Agenda Item #: 9

SUB-002696-2023 & MOD-002743-2023

Rangeline Crossing Subdivision, Phase Four,
Resubdivision of Lots 6-11

APPLICATION NUMBER <u>9</u> DATE <u>December 21, 2023</u>	
APPLICANT <u>Rangeline Crossing Subdivision, Phase Four, Resubdivision of Lots 6-11</u>	
REQUEST <u>Subdivision, PUD Modification</u>

SITE PLAN

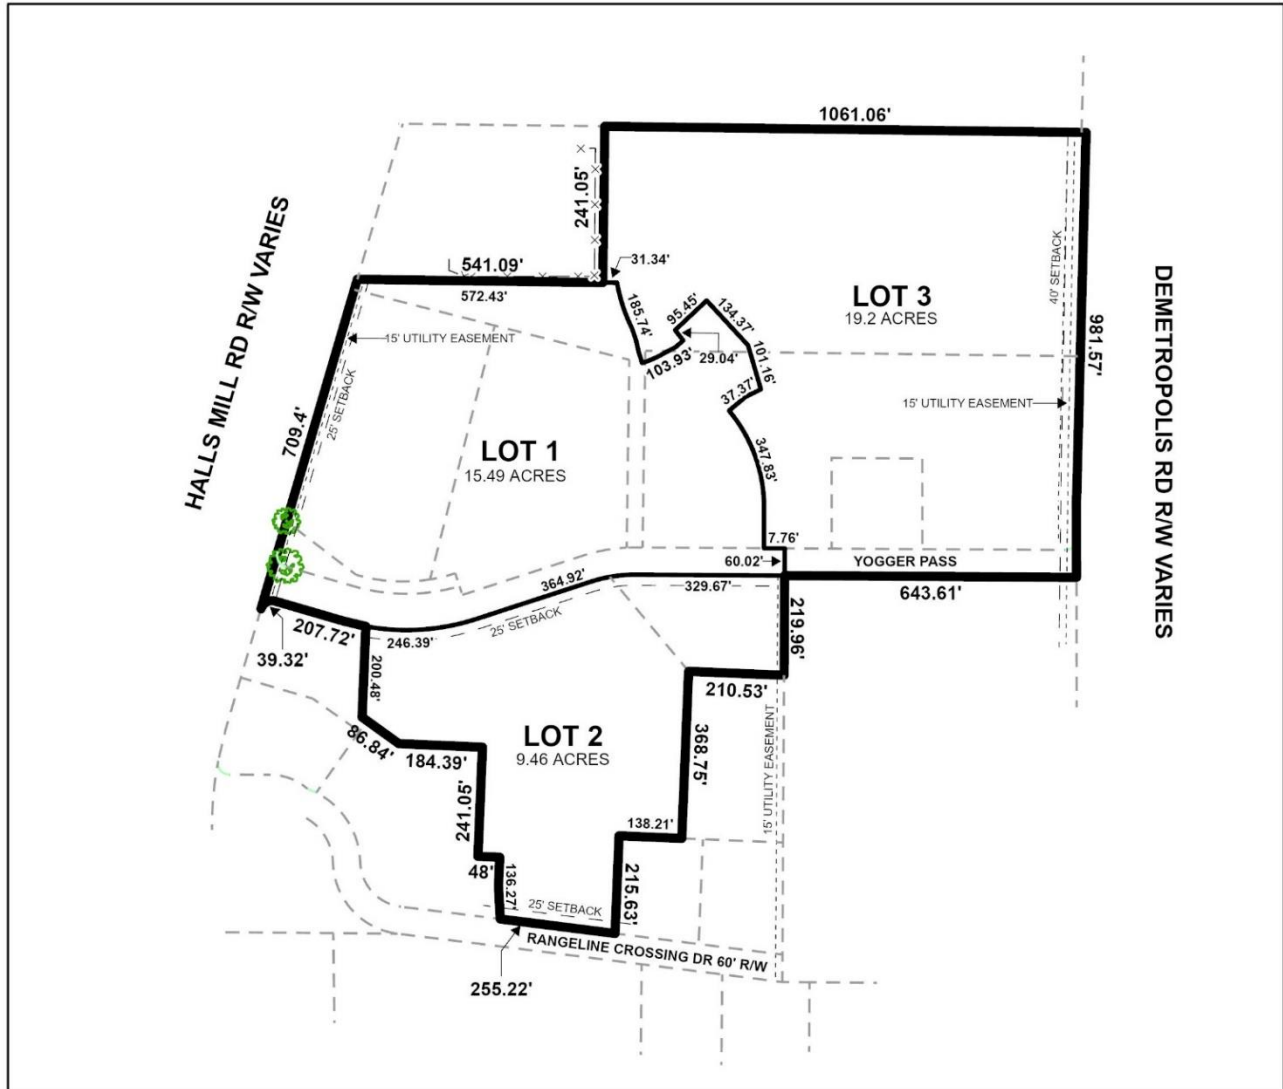
The preliminary plat depicts a 25-foot minimum building setback along all street frontages, with the exception of Demetropolis Road, which has a 40-foot setback, which should be retained on the Final Plat, if approved.

A 15-foot utility easement along Demetropolis Road is depicted on the preliminary plat, which should be retained on the Final Plat, if approved. Also, a note should be placed on the Final Plat stating that no structures are allowed in any easement without the permission of the easement holder.

It should be noted that Traffic Engineering comments will require a change to the site plan in how Rangeline Crossing Drive is accessed. The applicant should coordinate with Traffic Engineering to insure the proposed site plan will comply prior to being recorded in Probate Court.

The proposed site plan depicts a total of three (3) freestanding signs for the development. The applicant made the same request as part of the previous Planned Unit Development application, and the Planning Commission approval limited the development to two (2) signs, as allowed by right by the Zoning Ordinance. The applicant states they wish to have a sign at each entry to the development. As no additional justification was provided for the additional sign, the development should be limited to two (2) signs, as previously stipulated.

1. Depiction of the 25' minimum building setback along Halls Mill Road and Rangeline Crossing Drive;
2. Retention of the 40' minimum building setback line along Demetropolis Road;
3. Placement of a note stating that no structures are allowed in any easements without the permission of the easement holder;

6. Provision of a compliant photometric site plan at the time of permitting;
7. Site is limited to two (2) freestanding signs;
8. Provision of a note on the site plan stating future development or redevelopment of the property may require approval by the Planning Commission and City Council;
